BWR OWNERS' GROUP

BWROG-07026
May 22, 2007

SUBJECT: RESPONSES TO REQUESTS FOR ADDITIONAL INFORMATION (RAIS) DATED FEBRUARY 16, 2007, REGARDING THE BOILING WATER REACTOR (BWR) OWNERS' GROUP (BWROG) TOPICAL REPORT (TR) NEDO-33163, "HIGH BURN UP FUEL ROD GAP RELEASE FRACTIONS" (TAC NO. MD1764)

Responses to Requests for Additional Information (RAIs) dated February 16, 2007, Regarding the Boiling Water Reactor (BWR) Owners' Group (BWROG) Topical Report (TR) NEDO-33163, "High Burn Up Fuel Rod Gap Release Fractions" (TAC No. MD1764)

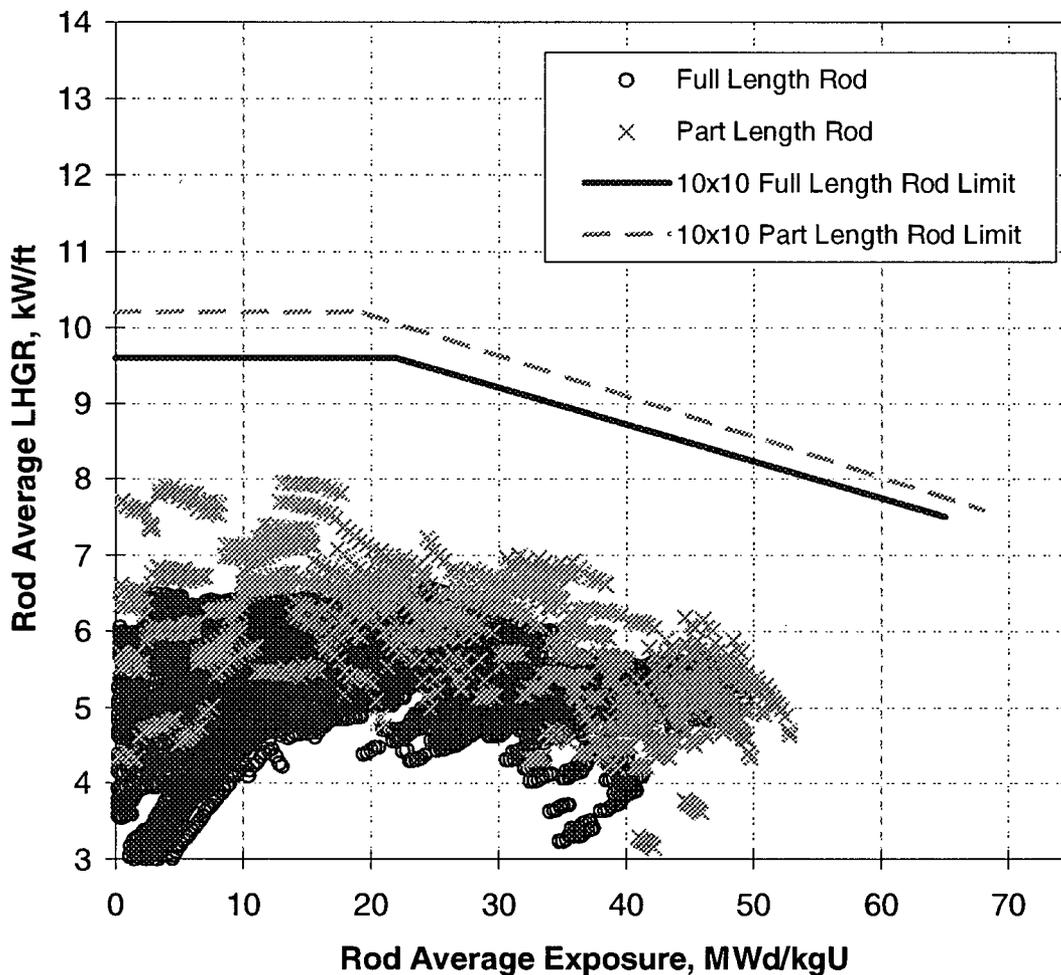
Please provide an example of how the rod average power versus burnup was determined for the curves in Figures 2.1 and 2.2 (e.g., provide a comparison of actual power histories used to determine the limit along with the limiting curve). An example for one fuel design is sufficient, preferably a design that operates the closest to the LHGR limit curves in Figures 2.1 and 2.2.

The bounding rod-average power versus burnup limits were developed to maximize rod gap fractions. Assuming the rods were operating on the LHGR curves reported in Section 2.3 of NEDO-33163, a conservatively low axial peaking factor was applied to maximize rod power over the entire exposure range. These results were then grouped by fuel type to arrive at the bounding curves in Figures 2.1 and 2.2. Experienced core designers at BWR licensees and fuel vendors then concurred with the expected bounding nature of these curves.

As an example, actual data from an aggressively burned GE14 bundle at an uprated BWR was plotted versus the bounding curves in Figures 2.1 and 2.2. As shown in the figure below, all the points are well bounded by the assumed limits. Thus, the curves reported in Figures 2.1 and 2.2 are considered con
